City of San Antonio

Re: **Johnson 328**

MDP # 029-07

The City Staff Development Review Committee has reviewed **Johnson 328** Master Development Plan **M.D.P. # 029-07**. Please find enclosed a signed copy for your files. Your plan was approved for acceptance; however please note the following conditions:

**JOHNSON 328
MASTER DEVELOPMENT PLAN**

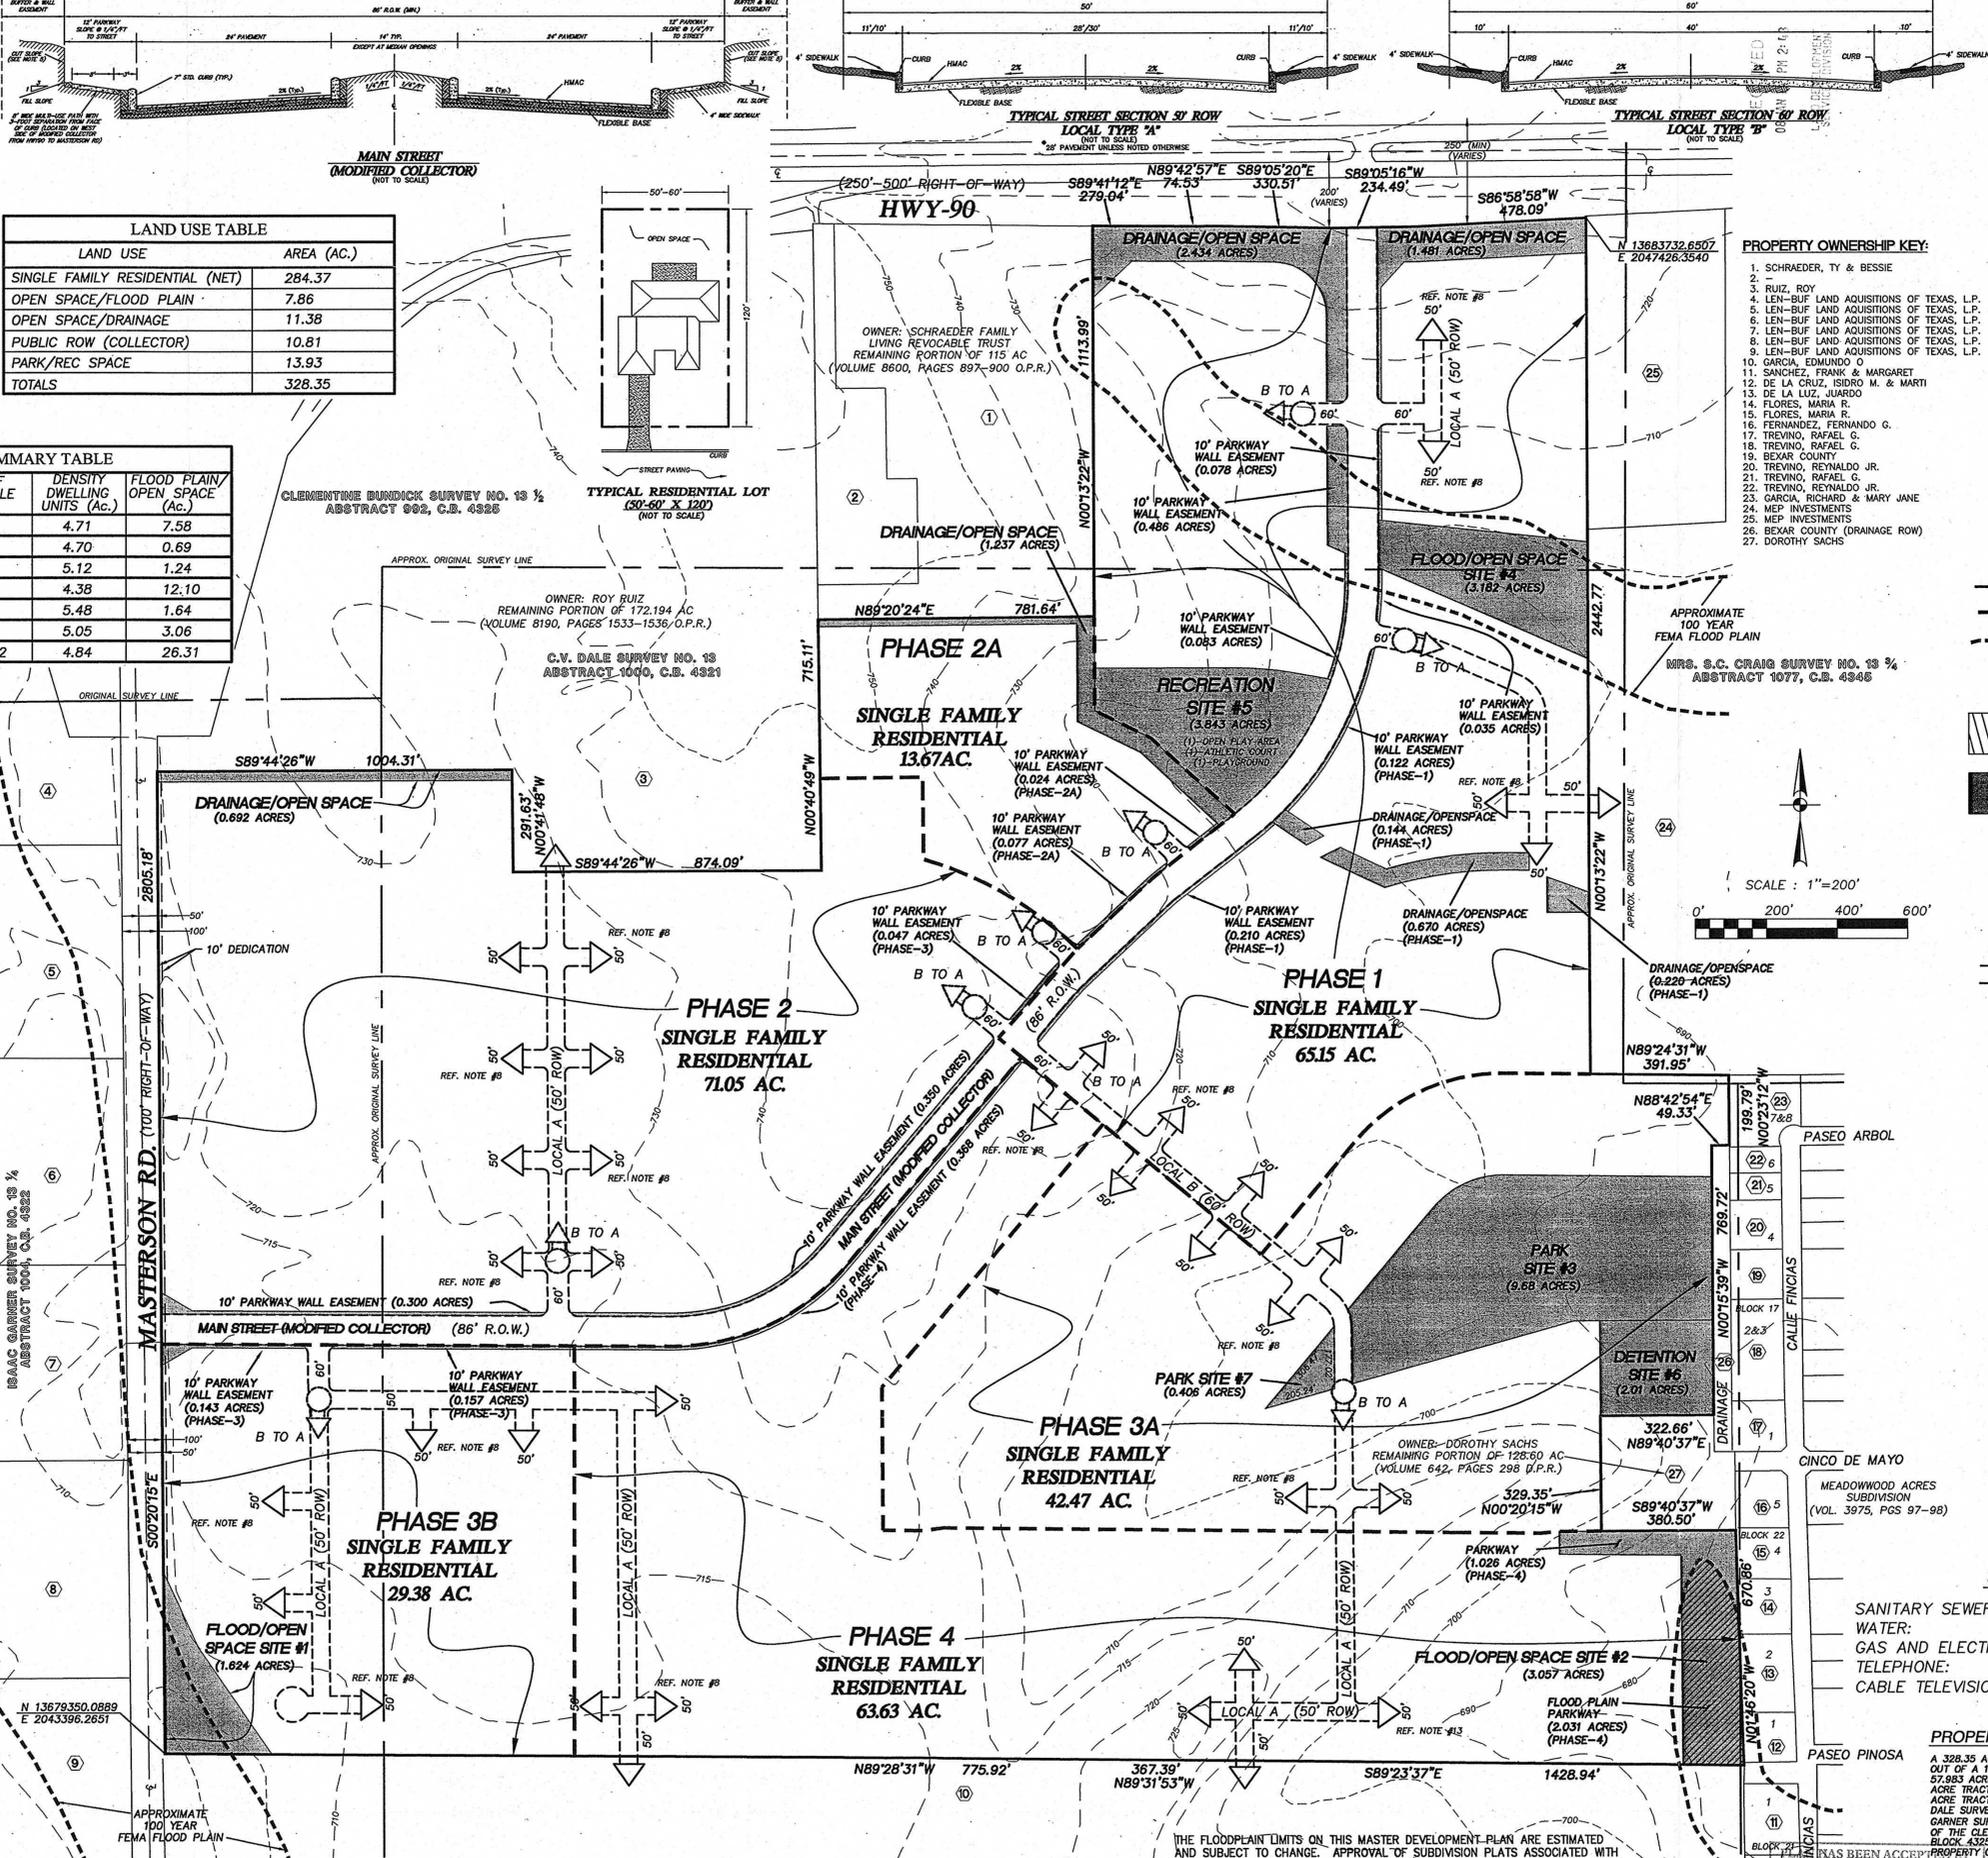
In consideration of public safety and convenience, excessive grades by reason of topography should be avoided in street layouts and arrangements. Any access and R.O.W. issues along state facilities will need to be resolved with the **Texas Department of Transportation (TXDOT)**. For information about these requirements you can contact TXDOT at 615-5814.

- All roadways shall follow UDC §35-506(C)(1), Table 506-1: Functional Classification System Description and comply with UDC §35-502(a)(9).
- All landscaping and improvements shall be selected and located in such a way not to block the clear sight distance areas.
- Coordination with TXDOT concerning access to development site from U.S.90 Highway is required.
- A dedicated left-turn lane at southbound Masterson Road at the proposed Main Street.
- A separate right-turn deceleration lane on the eastbound approach of U.S. 90 at the intersection with the proposed Main Street.
- An acceleration lane for the right-turn traffic exiting the site onto U.S. 90.
- A through left-turn lane and a dedicated right-turn lane at the northbound approach of the proposed Main Street at U.S. 90 to accommodate the outbound traffic.

Note: Secondary access must be secured prior to the approval of any plat or combination of plats exceeding 125 dwelling units; UDC §35-506(e)(7).

- The parkland provided shall be shown as “Park” or “Open Space” on a plat; UDC § 35-503(e) *Designation of Parkland*.
- The parkland provided shall be dedicated to the Homeowners Association.
- The instruments creating the Homeowners Association shall be provided by the second application for plat approval; UDC § 35-503(e) *Designation of Parkland*
- Parkland dedication shall be platted by the second phase of residential development; UDC § 35-503(f) *Development Phasing*.

- 2006 Tree Preservation ordinance standards per UDC § 35-523 – a Tree Preservation Plan is required prior to any work on site. This can be submitted either as a site work permit or at the platting stage. Additional permitting fees and affidavits will be needed to obtain tree permits during the platting and/or building permit stages.
- Streetscape standards per UDC § 35-512 - The new ROW collector will require streetscaping as well (we recommend preservation of existing trees where available and possible).

The Texas Sites Atlas indicates that no archaeological sites have been previously identified within the above referenced property. However, the project area is located in close proximity to Big Sours Creek and Lucas Creek, two waterways known to contain significant sites; therefore, there is a **high probability** that the property may contain sites, some of which may be significant. Thus, before any work that might affect any sites is begun, we recommend that a qualified professional conduct an archaeological investigation of the property.

- Access to US 90 shall be mandated by the Texas Department of Transportation.
- Traffic Controls shall be provided as warranted and installed according to standards of the Texas Manual on Uniform Traffic Control Devices and approved by Bexar County and/or TXDOT.
- A left turn lane on the southbound lanes of Masterson Road shall be installed according to the standards of the Texas Roadway Design Manual and shall be inspected and approved by Bexar County.
